FINAL
PRELIMINARY ENGINEERING REPORT

I-275 FROM ROOSEVELT BOULEVARD
TO 4TH STREET NORTH
PINELLAS COUNTY, FLORIDA

State Project Number: 15190-1426
WPA Number: 7147848
FA Number: IR-275-7(218)22

This is in response to your facsimile dated October 25, 1990 and the Federal Highway Administration letter dated October 16, 1990 regarding comments on the draft preliminary engineering report prepared for the subject study.

FIGURE 8-10

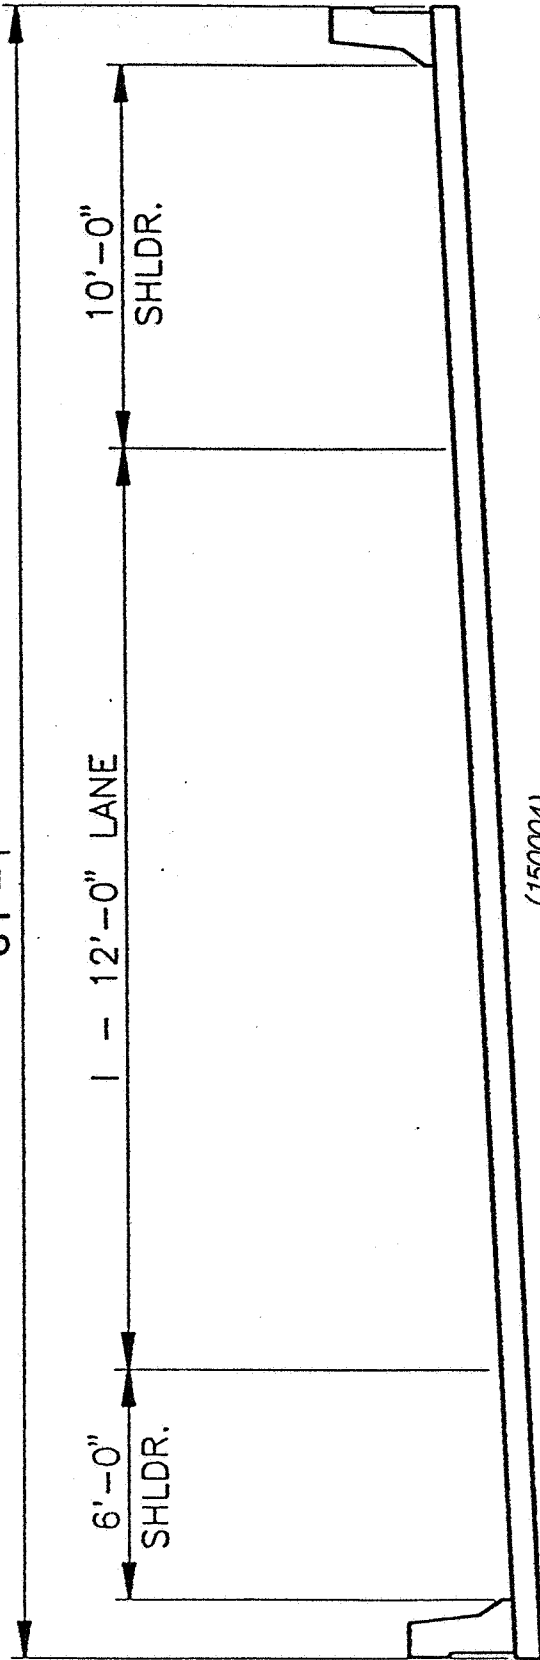
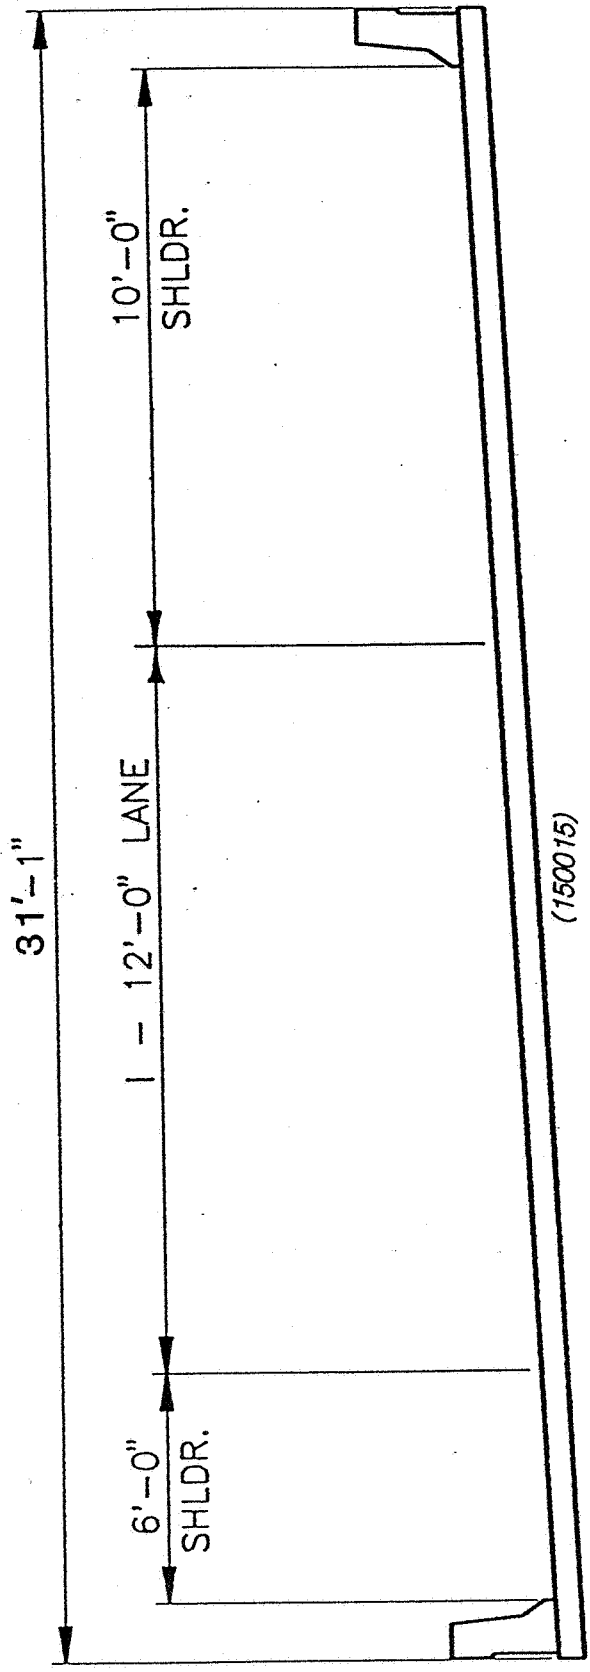
3. Superstructure - Figures 8-10 and 8-12 show two lane bridges for the 4th and 9th Street southbound ramps. Traffic does not warrant two lanes. Evaluate providing the width for a 1-lane ramp with the provision for passing a stalled vehicle.

Response: During the analysis phase of the study, it was determined that projected traffic volumes for the respective ramps required only 1-lane to provide sufficient capacity. The recommendations to replace the bridges with 2-lanes was based upon existing conditions. The existing bridge structures provide for 2-travel lanes. Both structures were re-evaluated to determine the required bridge width necessary to provide 1-lane with an acceptable clear zone. The proposed degree of curvature from the 9th Street ramp is 5° 45'. The required clear zone to provide safe operating conditions is 19 feet. Although the 9th Street bridge is located within the 80 percent transition of the superelevation, it is recommended to assure safe operating conditions that the 19 feet of clear zone be carried across the length of the bridge. This will result in an outside to outside bridge typical section of 40 feet 1 inch for the 9th Street bridge. A net reduction of three feet will occur from the originally proposed typical section.

Both bridge typical sections have been revised to show the appropriate bridge width. The cost for the 4th Street bridge has been reduced accordingly.
